Enclosed please find a copy of the comments prepared by the State of Nevada on the U.S. Department of Energy's draft Environmental Assessment concerning a proposed nuclear waste repository site at Yucca Mountain.

The State of Nevada has completed its review of the draft Environmental Assessment (EA) issued by the Office of Civilian Radioactive Waste Management on December 20, 1984. The document containing our comments is enclosed for your review and response.

*U. S. Department of Energy Draft Environmental Assessment
for the Proposed High-Level Nuclear Waste Site
at Yucca Mountain*

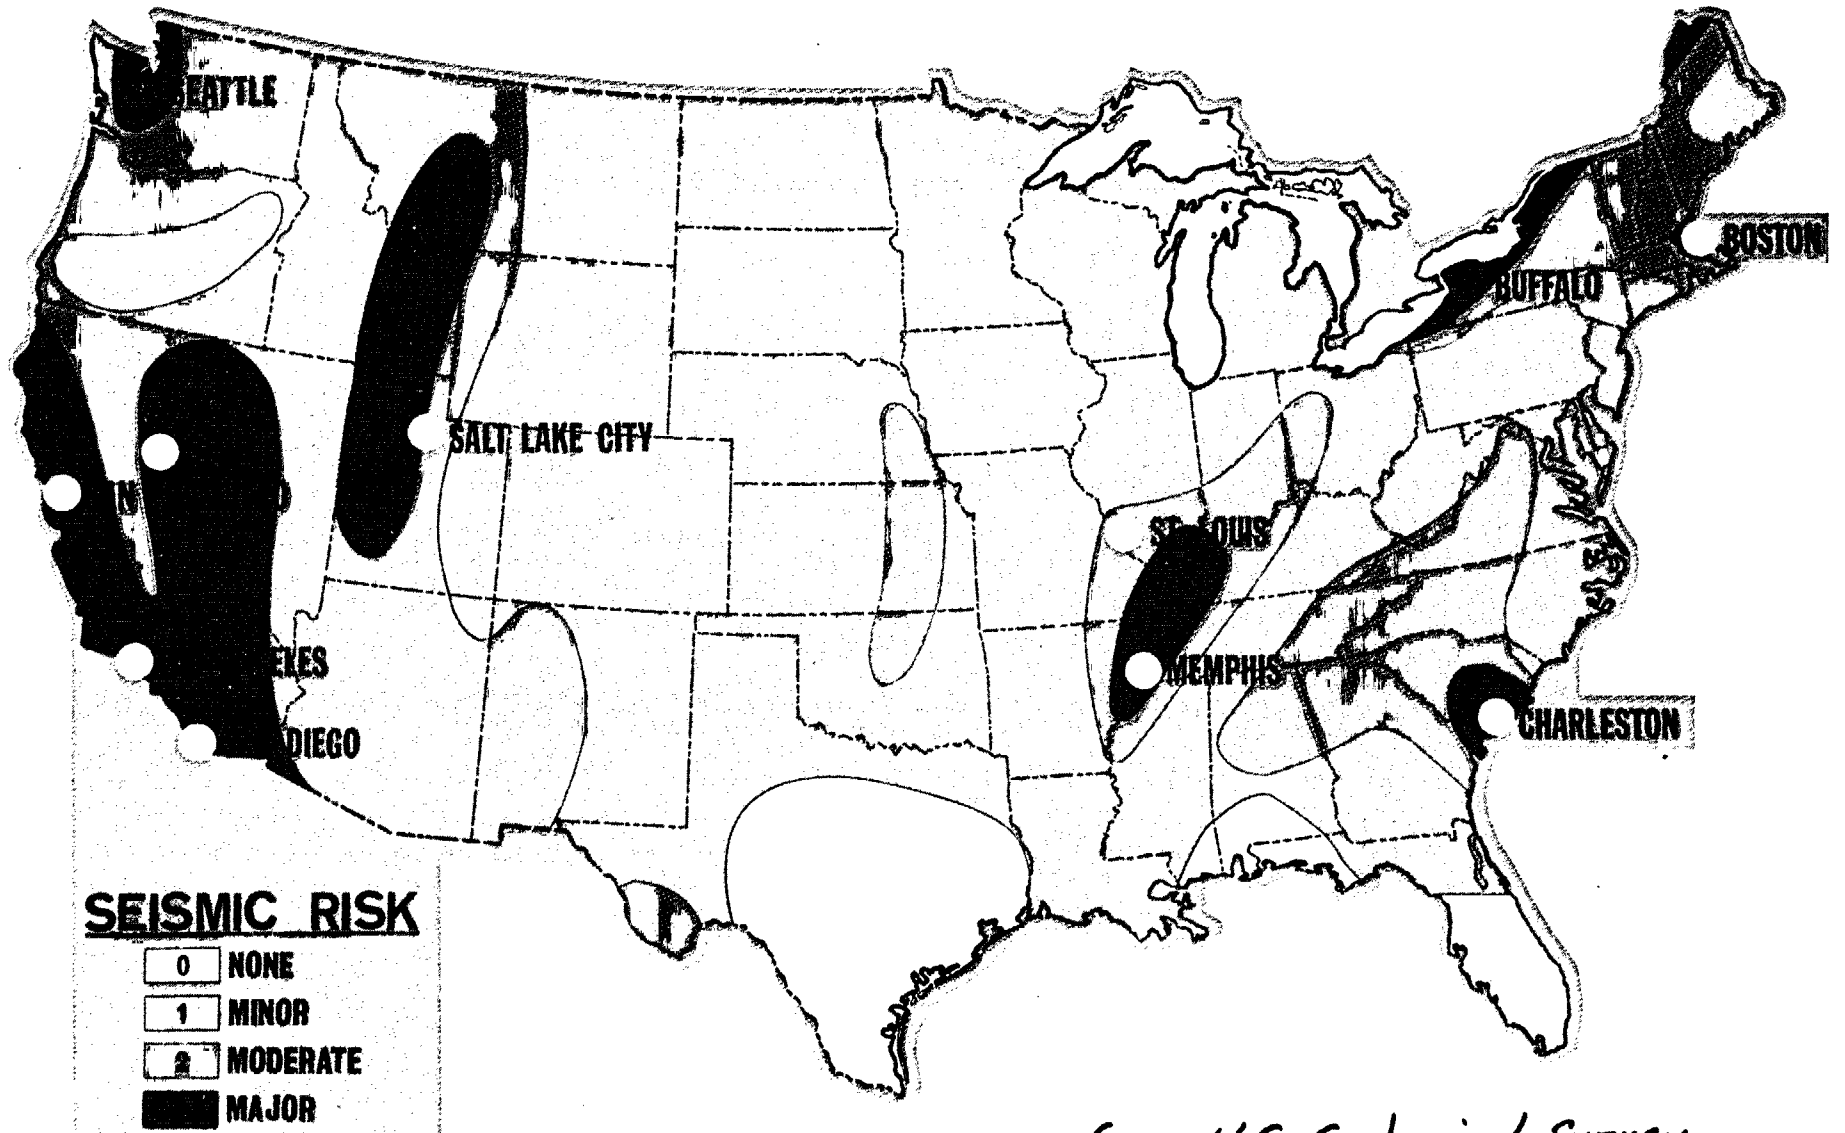
The draft EA compares five sites against the guideline on geohydrology (960.4-2-1) at pp. 7-5 through 7-15. Table 7-1 and the text at p. 7-11 conclude that Yucca Mountain is the only site of the five where favorable condition 2 is not present. Table 7-1 and the text at p. 7-13 also conclude that Yucca Mountain is the only site of the five in which a particular potentially adverse condition is present. (The favorable and potentially adverse conditions at issue involve the nature and rates of hydrologic process operating within the geologic setting which affect the ability of the repository to isolate waste, and the presence of ground-water sources suitable for crop irrigation and human consumption without treatment along ground-water flow paths from the host rock to the accessible environment, respectively.) There is no discussion in Chapter 7, however, revealing that the absence of the favorable condition or the presence of the potentially adverse condition affected in any way the comparative evaluation of the five sites for purposes of ranking.

Figure 3-10. Location of metal deposits, industrial minerals, thermal waters, and mining districts in the vicinity of Yucca Mountain. Modified from Bell and Larson (1982) and Trexler et al. (1979).

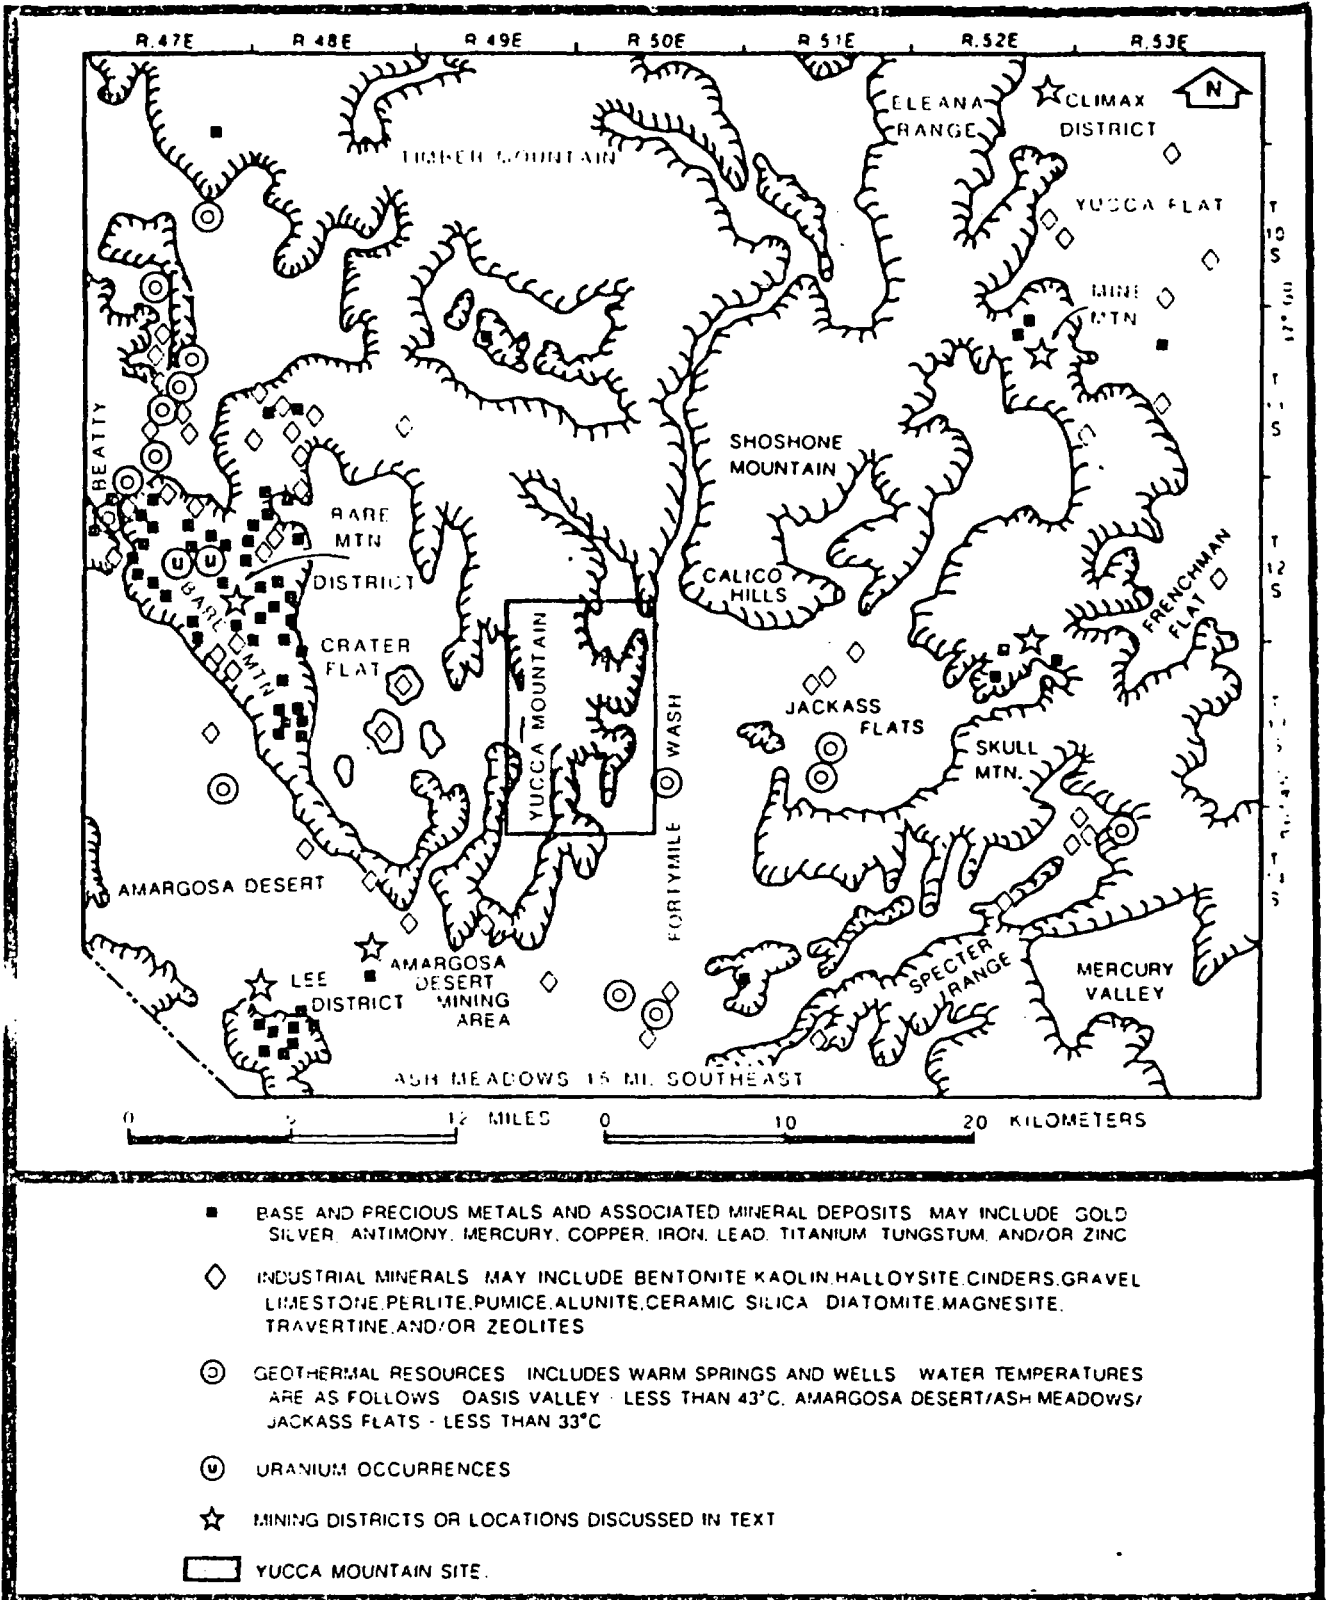
Within the Yucca Mountain Site itself, zeolites occur at depth (1,300 feet or greater). Non-commercial amounts of gold and silver occur in the lower Tram Member of the Tertiary Crater Flat Tuff Formation at 3,515 feet in drill hole USWG-1 which consisted of 0.016 oz gold/ton and 0.64 oz silver/ton (Spengler et.al., 1981). Hydrocarbon resources have not been detected in any drill holes in the vicinity of Yucca Mountain. Low to moderate geothermal resources exist at depths less than 3,300 feet at Jackass Flats, southeast of Yucca Mountain. Figure 3-10 shows the location of metal and industrial minerals, thermal waters and mining districts in the vicinity of Yucca Mountain.
